UNITED STATES PATENT AND TRADEMARK OFFICE

Office Action Summary

10/724,188

KUSAK, JIRI

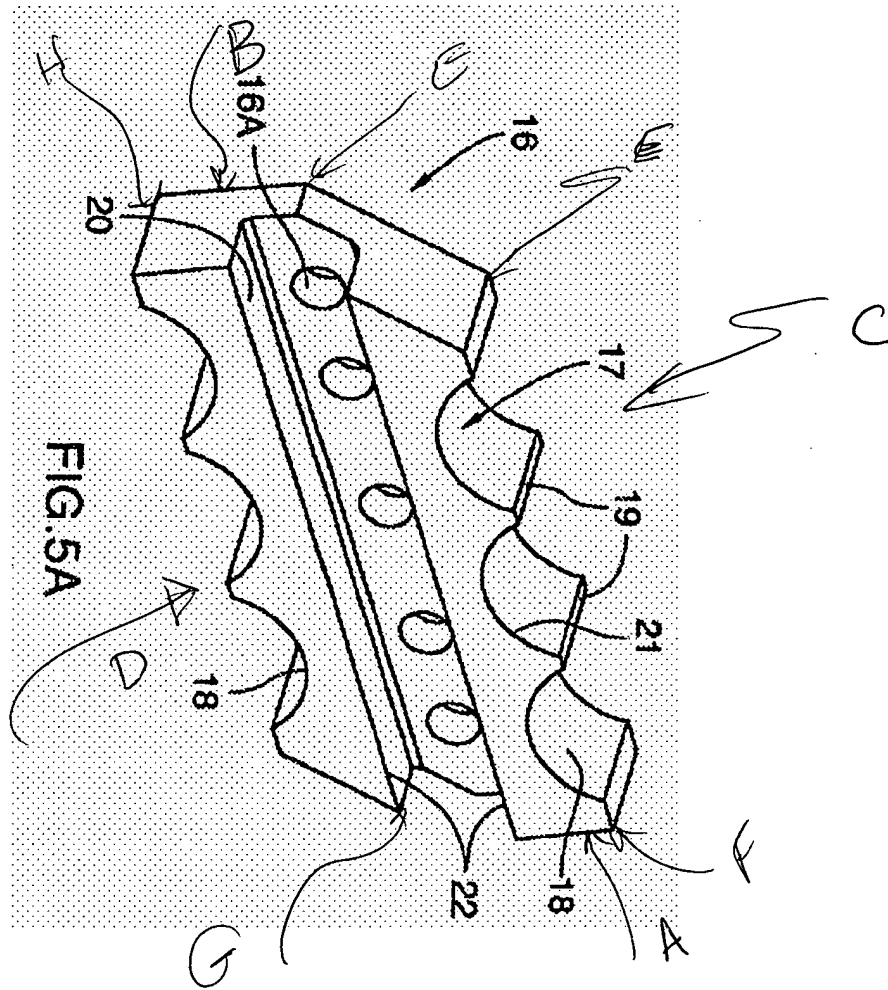
4. Claims 1-12 are rejected under 35 U.S.C. 102(e) as being anticipated by Dorscht [US 2003/0230657].

Dorscht discloses in Figs 5A and 5B (also see Figure below wherein the letters A-H have been added by the examiner), a striker plate comprising a striker plate having: a first end face A, a second end face B, a rear face for attachment to a rotor or anvil, a front face parallel the rear face, a right cutting side face C extending between the rear

face and the front face on a right side thereof, and a left cutting side face D extending between the rear face and the front face on a left side thereof, a right rear cutting edge E formed at a juncture between the right side cutting face and the rear face.

Additionally, Dorscht discloses a right front cutting edge F formed at a juncture between the right side cutting face and the front face, a left front cutting edge G formed at a juncture between the left side cutting face and the front face, a left rear cutting edge H formed at a juncture between the left side cutting face and the rear face. the right cutting side face comprising a plurality of identical planar right lands [pierce points 19] interspaced by a plurality of identical, parallel right grooves [surfaces 17]. Also, Dorscht discloses the right lands all lying in the same flat right land plane and each spaced from each adjacent right land by one of the right grooves, the right land plane disposed at a first angle to the rear face, each right groove comprising a frusto-cylindrical surface of an angular extent not greater than 180 degrees about a respective groove axis extending at a second angle to the rear face, wherein the first angle is 90 degrees [Figs 5A and 5B], at least one bore [holes 16 A] through the striker plate from the front face to the rear face.
